2019 GROUP B PROPOSED CHANGES TO THE I-CODES ALBUQUERQUE COMMITTEE ACTION HEARINGS

2018-2019 Code Development Cycle, Group B (2019) Proposed Changes to the 2019 *International Codes*

FIGURE AS105.1(4)
TYPICAL TOP OF POST-AND-BEAM WALL
WITH PLASTERED STRAW BALE INFILL

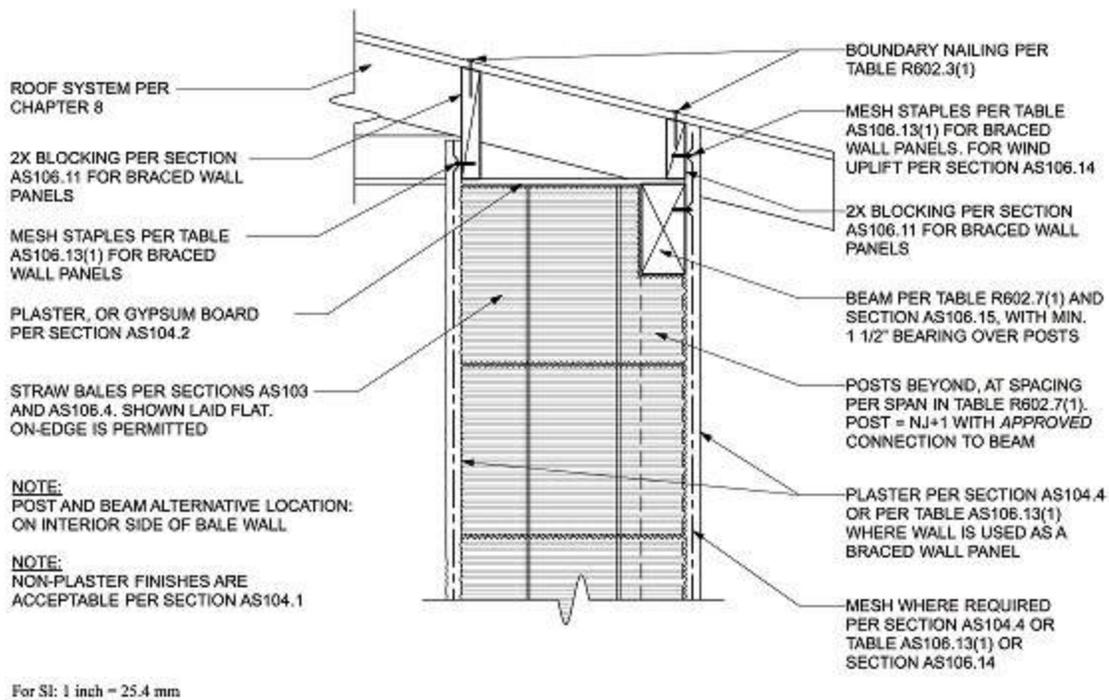
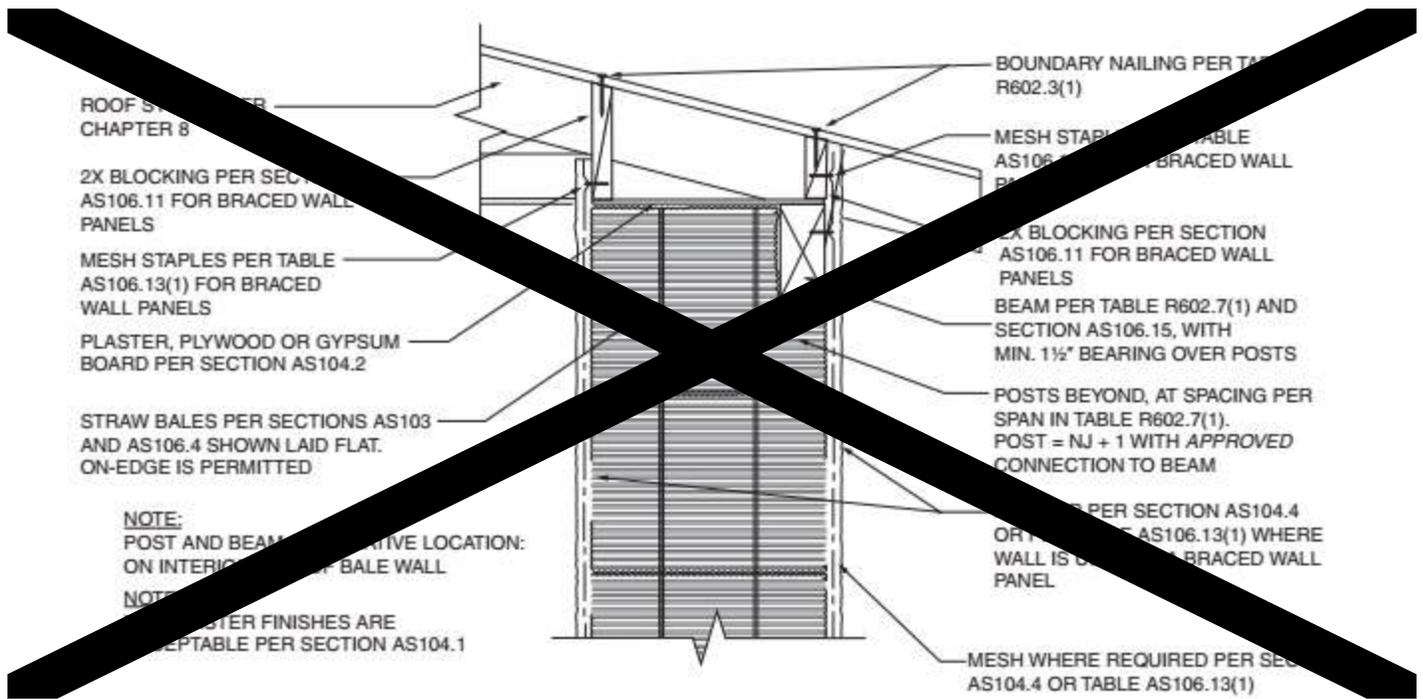
Revise as follows:
